Chapter 3

3-2 – 12

3-2-12 PC1

ATTACHMENT B TO AMERICAN HOTEL & LODGING COMMENTS
 IMPACT OF PROPOSED CHANGES TO TURNING RADIUS

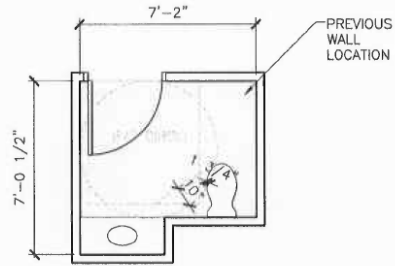
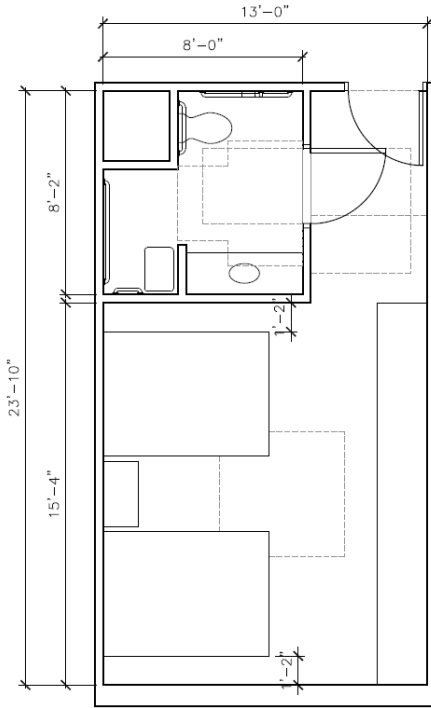
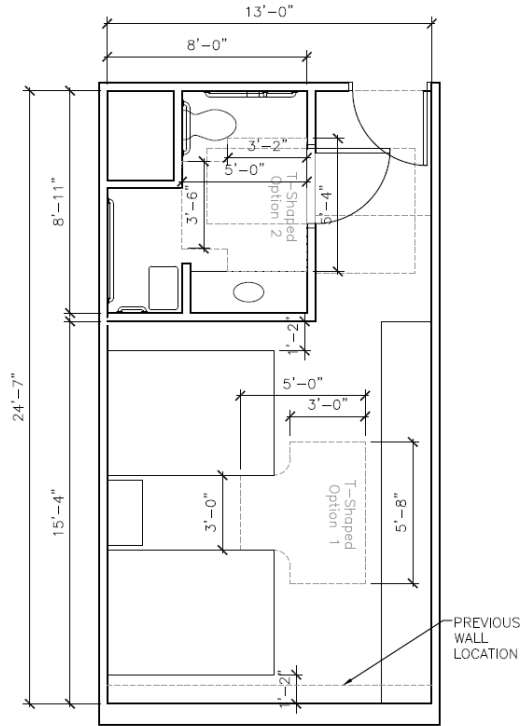
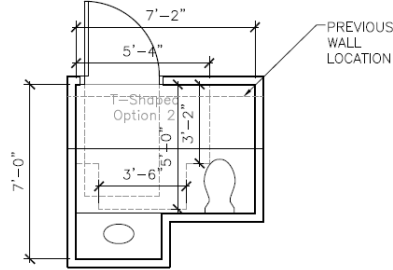
Attachment B contains some preliminary drawings showing the impact of the larger proposed turning radius and clear floor space requirement on a typical accessible guestroom, a single user restroom and a U-shaped kitchen. See Attachment B. The drawings show that the enlarged turning radius will require a typical 13' wide accessible guest room to be at least 7" wider and 14 square feet larger overall. Because a typical hotel is required to have a number of accessible guest rooms (approximately three percent (3%) of inventory), the impact will be very significant. Single-user restrooms will have to be at least 4.5 square feet larger and U-shaped kitchens will have to be at least 8 square feet larger. Every access aisle for accessible parking spaces also will have to be 7" wider, thereby decreasing the overall number of parking spaces that can be provided on a site.

Another very significant proposed change to the T-turn provision is the elimination of an existing provision that allows a portion of the T-turn space to overlap the knee/toe clear space that must be provided under an obstruction such as a bathroom vanity. As shown in Attachment C, this deletion, when combined with the increased space requirements for a T-turn, results in an accessible guest room that must be approximately 10 square feet larger. In a single user restroom, the proposed T-turn changes would require an increase of 3.5 square feet to a typical single user restroom.

The impact of the T-turn change is especially problematic in the accessible guestroom scenario because the length of the entire room would have to be increased by 9", making the accessible room longer than the standard room. This is an untenable situation in both new construction and alterations. In new construction, the lengthening of one room type would cause all other rooms on that corridor to be deeper, resulting in decreased room count. In existing facilities, there would be no way to lengthen the room because doing so would intrude into the corridor. Thus, the better option for providing a turning space in this room configuration is to use the 67" radius shown in Attachment B which would require the room to be 14 square feet larger.

FIG. 804.2.1
PASS-THROUGH KITCHEN CLEARANCE

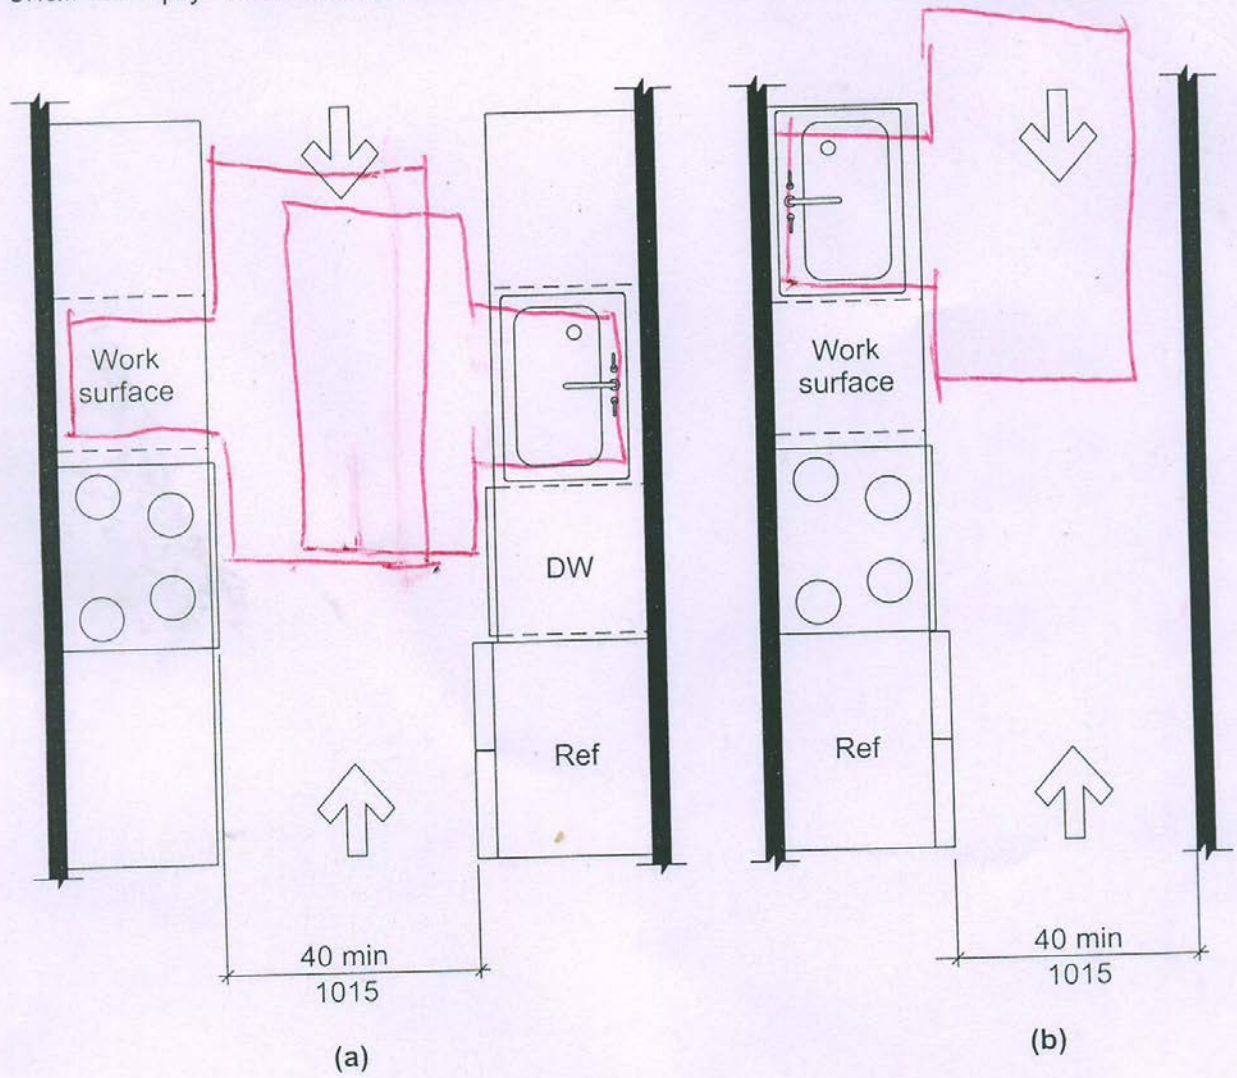
The new exception is intended to allow for some design options in kitchens. If that turning space is provided in U-shaped kitchen under the sink or work surface, then the provisions to access each side of the kitchen is addressed through the alcove provisions (which the committee decided to leave at 60".) If a T-turn is not provided because the work surface or sink is near a corner, then the space between the counter will provide a circular space. See figures for examples. In addition, this will maintain the 15 step work triangle which is important to the efficiency of a kitchen for standing persons.

shall comply with 804.2.1

Figure 304.3.1

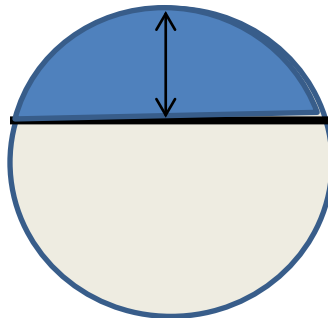
Reason: The intent of the original proposal was to eliminate the 'donut' effect currently permitted with the turning circle. However, in order to be consistent with the T-turn in Section 304.3.2, the depth on that one side should be permitted to be the same depth as the knee and toe clearance provided.

304.3.1 Circular Space. The turning space shall be a circular space with a ~~60-67 inch (1525 1700 mm)~~ minimum diameter. The turning space shall be permitted to include knee and toe clearance complying with Section 306. Where the turning space includes knee and toe clearances under an obstruction, the overlap shall comply with all of the following:

- ~~1. The depth of the overlap shall not be more than 10 inches (255 mm), and~~
- ~~2~~ 1. The depth shall not exceed the depth of the knee and toe clearances provided, and
- ~~3~~ 2. The overlap shall be permitted only within the turning circle area shown shaded in Figure 304.3.1.

Figure 304.3.1

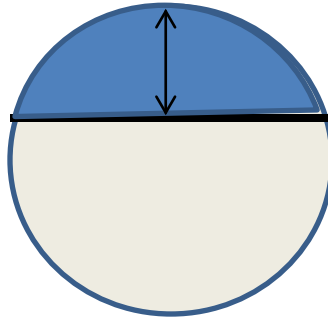
Reason: 1. States overlap not more than 10". 2. Conflicts with #1 since knee clearance would be 18 or 19-inch depth which exceeds the 10-inch limit states in #1 and #3 increases the confusion by referring to the nearly 50% shaded area in the Figure 304.3.1. Delete #2 and #3 and the figure and leave #1 as that is clear on what a designer should do.

304.3.1 Circular Space. The turning space shall be a circular space with a 60-inch (1525 mm) minimum diameter. The turning space shall be permitted to include knee and toe clearance complying with Section 306. Where the turning space includes knee and toe clearances under an obstruction, the overlap shall comply with all of the following:

1. The depth of the overlap shall not be more than 10 inches (255 mm), and
- ~~2. The depth shall not exceed the depth of the knee and toe clearances provided, and~~
- ~~3. The overlap shall be permitted only within the turning circle area shown shaded in Figure 304.3.1.~~
